Project Memorandum

To Laura Oliver, Deputy Recorder
From Shay Stark, Contract City Planner
Date February 5, 2020
CC
Subject Houghton Subdivision Review

Technical Review Comments

FIGURE 13-1

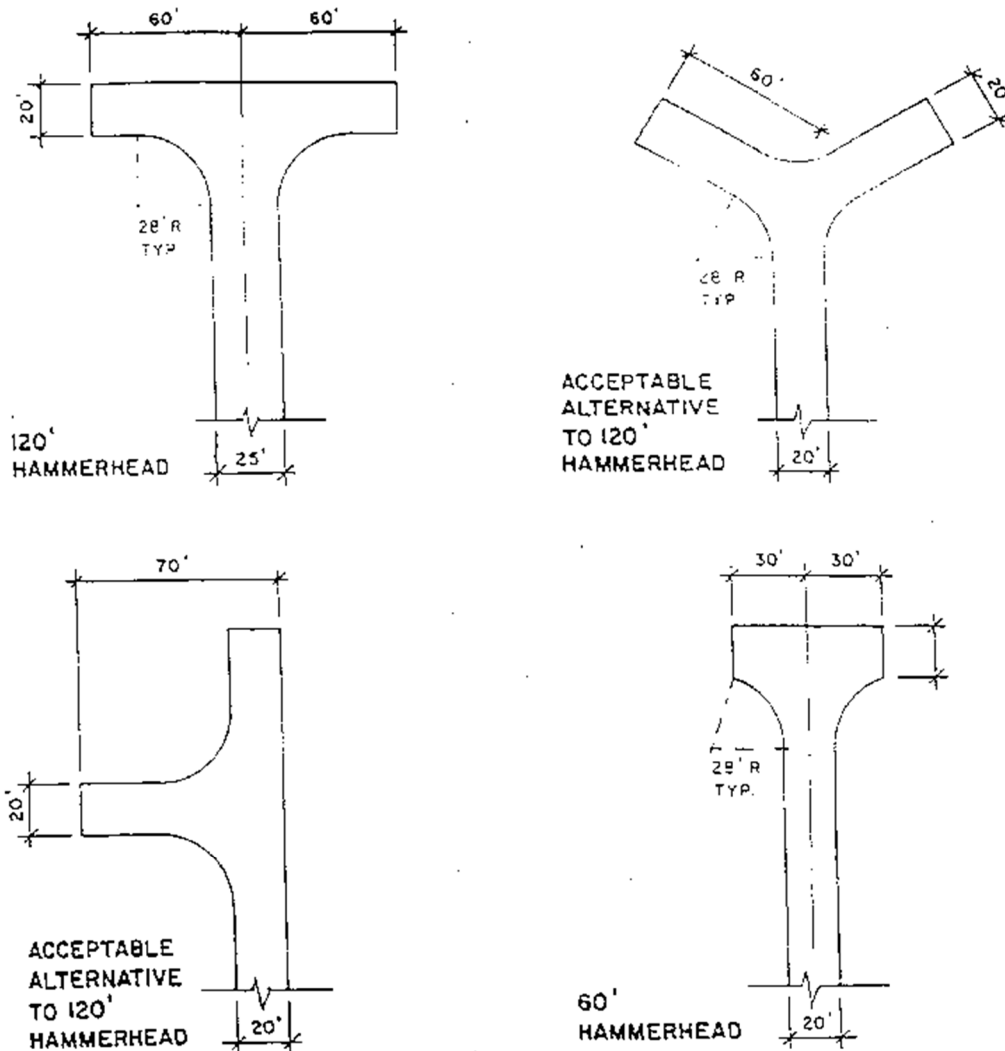
C. Curves: All curves to the driveway shall conform to the minimum standards set forth under figure 4. Each drive shall terminate with a turnaround or hammerhead conforming to the requirements set forth, as applicable in attachments 2 and 3.

Please see the two drawings attached at the end of this memo for details on access configuration.
